Subject: Revised Submission Materials - Case 21946

ATTACHMENT A: Response to Comments

ATTACHMENT A: RESPONSE TO STAFF COMMENTS

ATTACHMENT B: Revised Site Plan for BH-1

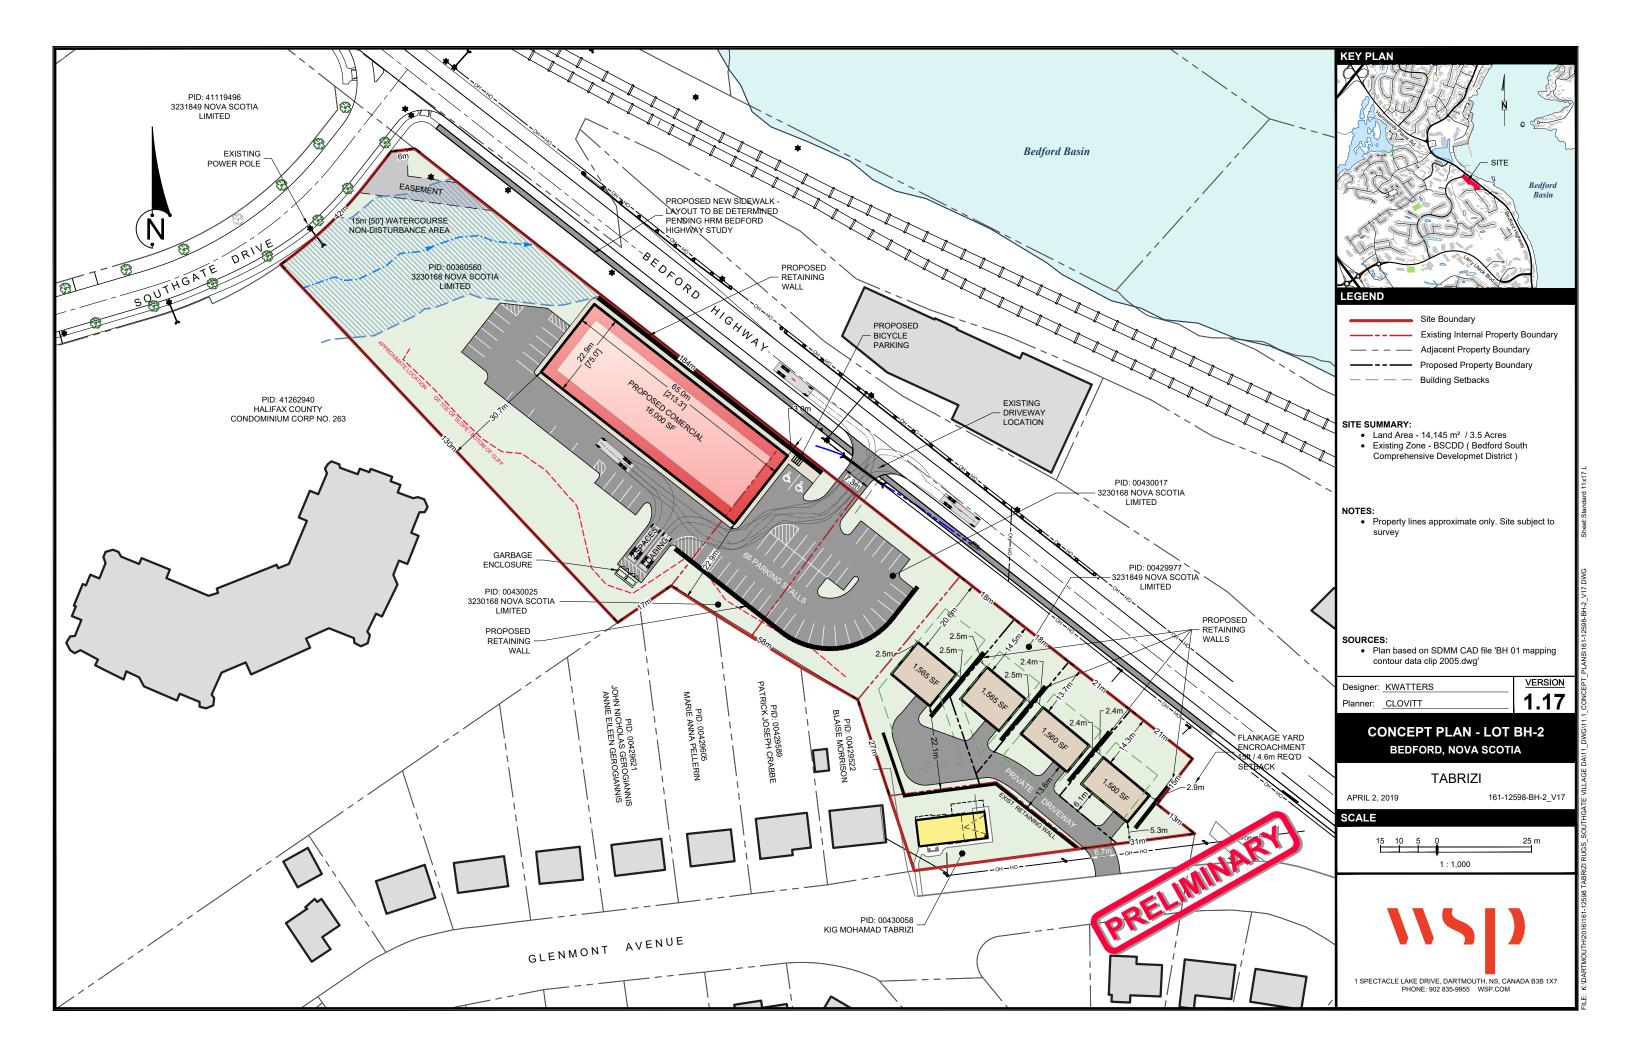
3. The proposed site plans must show area of proposed buildings, setbacks from all property boundaries, building access point with FFE;	See revised site plans for BH-1 and BH-2 (Attachment B and C) For building elevations, see Attachment F: Grading Schematic.

5. The proposed site plans must dimension driveway access widths;	See revised site plans for BH-1 and BH-2 (Attachment B and C)	
6. The proposed site plans must show surface types, areas of existing vegetation to be retained;	See Preliminary Landscape Plans (Attachment J)

COMMENT REFERENCE	RESPONSE	
Engineering Comment 1	The driveway coming from the underground parking garage has been widen to 7.0m to assist in improved visibility.	
Engineering Comment 5	We understand that a sidewalk is recommended to be extended the entire length of the subject properties. This can be discussed in the terms of the DA.

# ATTACHMENT F:

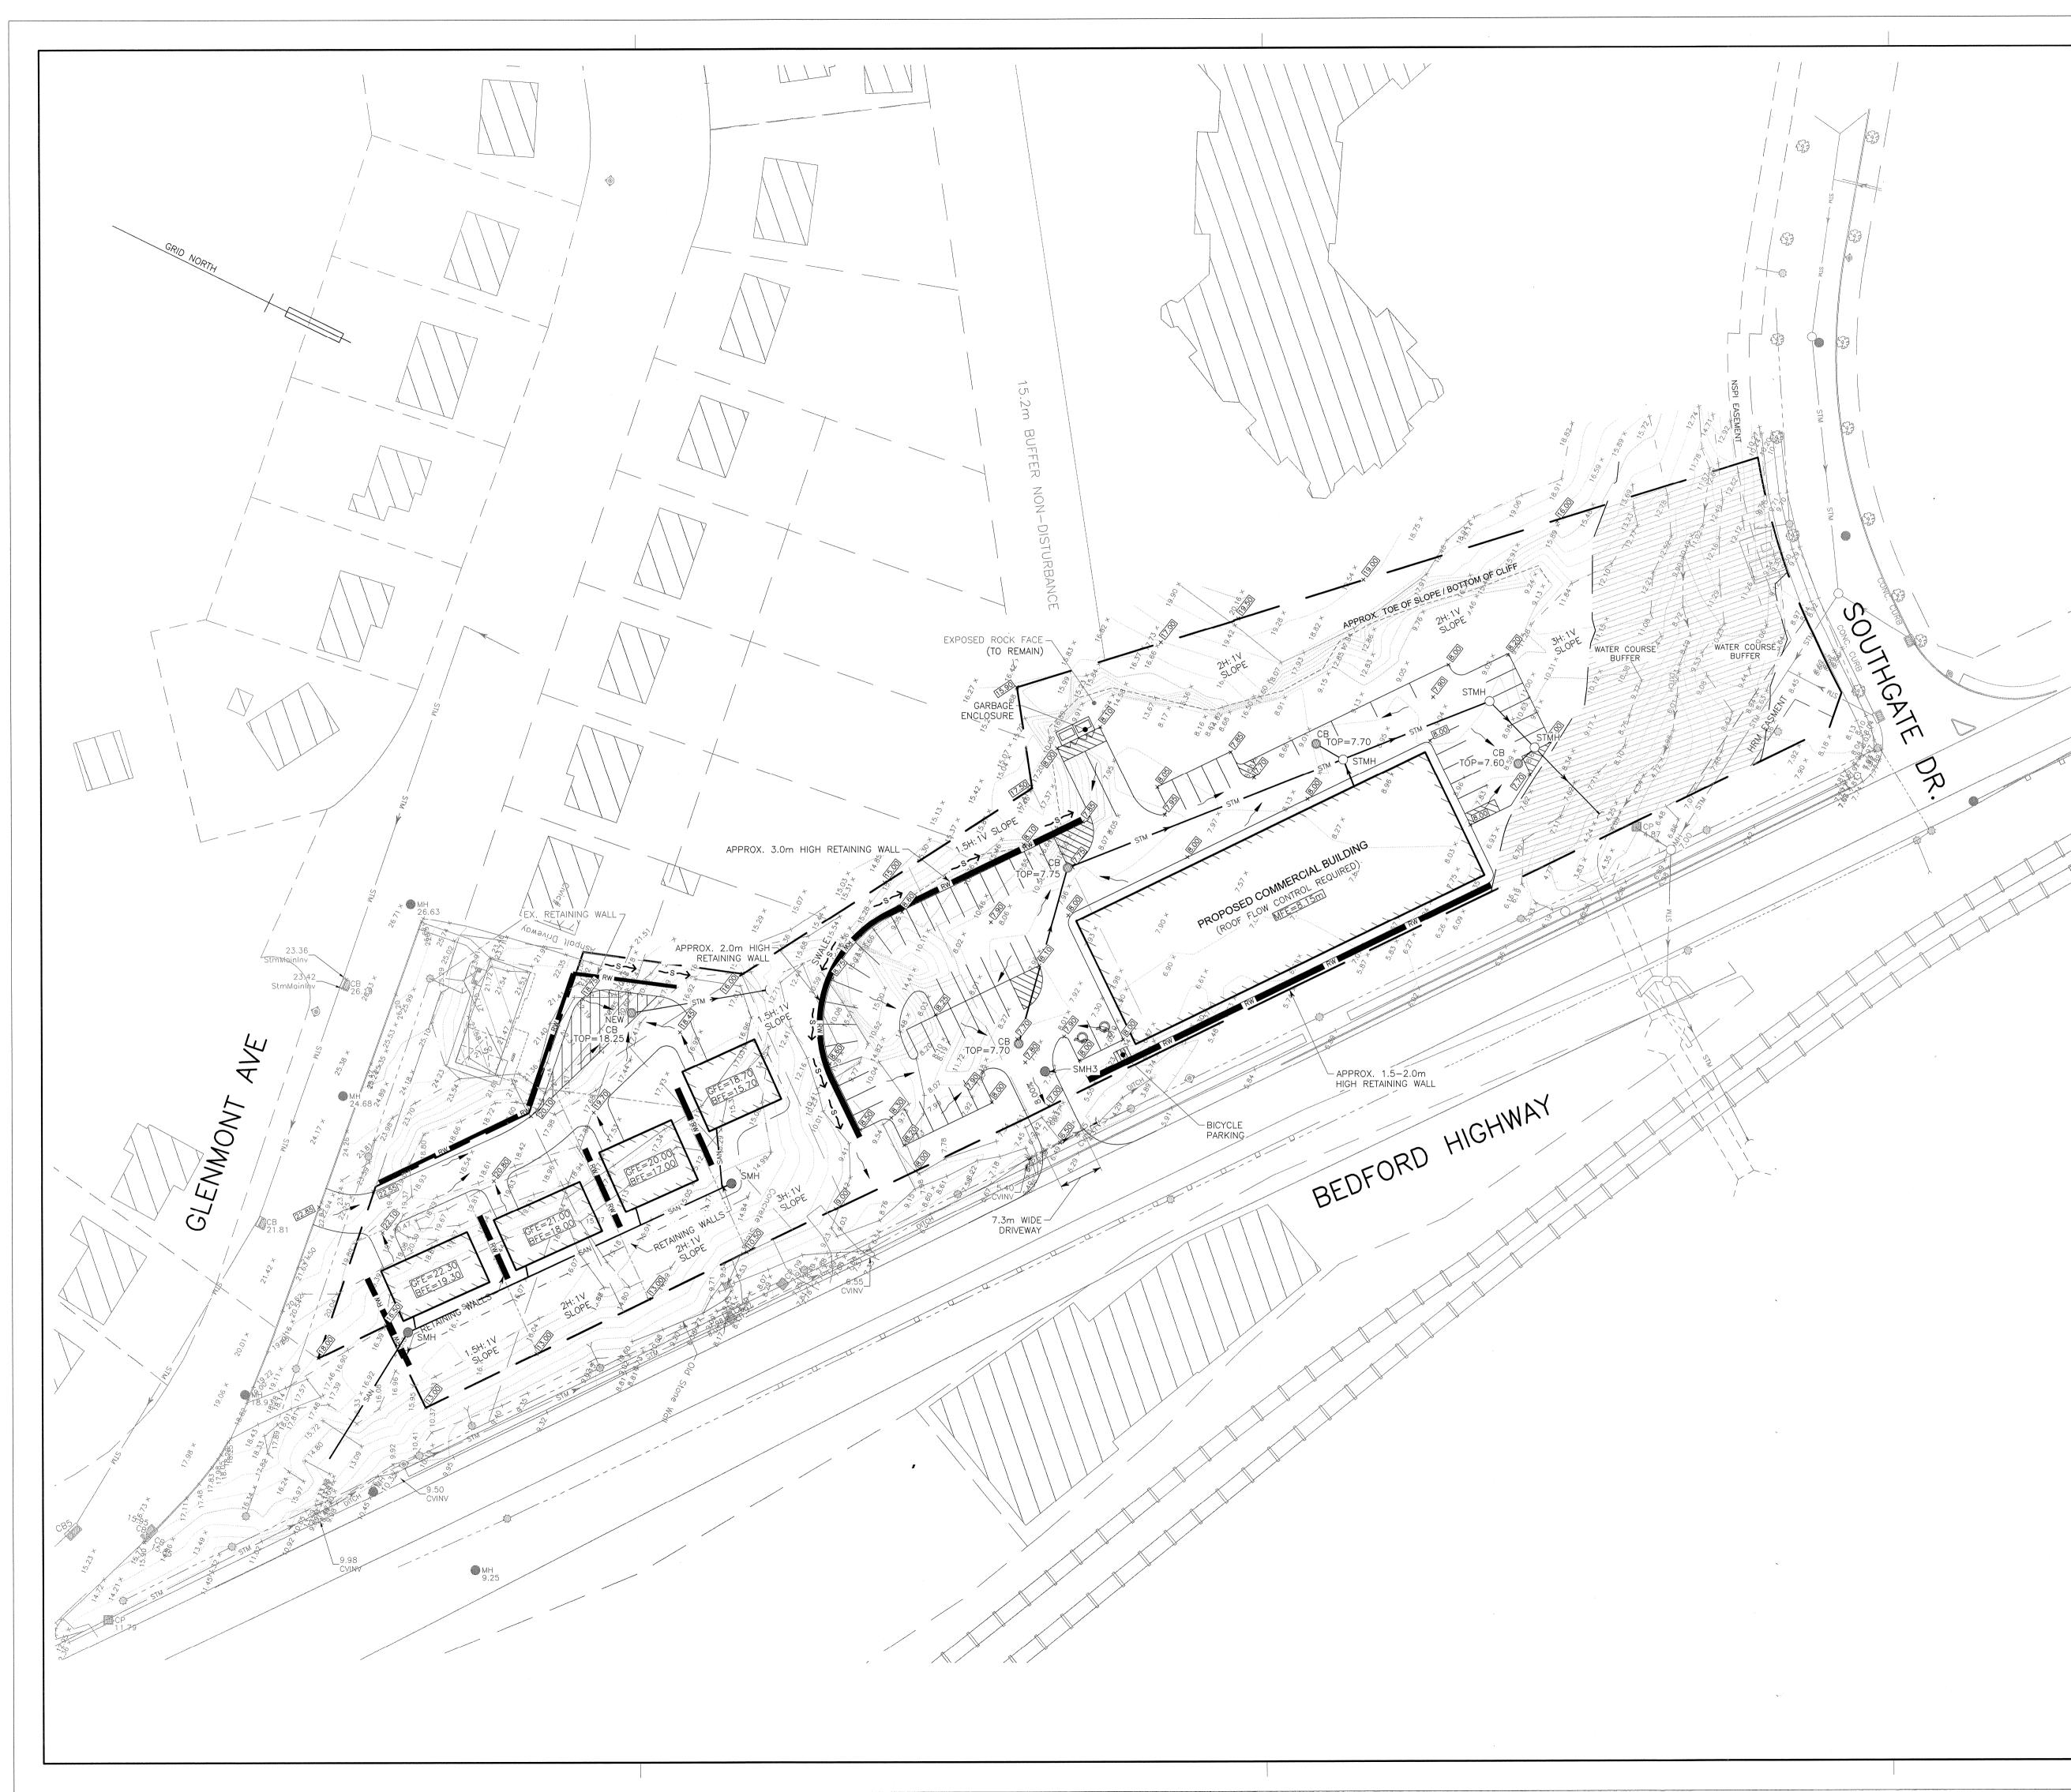
4. The proposed site plans must show existing and proposed grades, spot elevations at all building corners and high points or low points on the site;	See Attachment G.
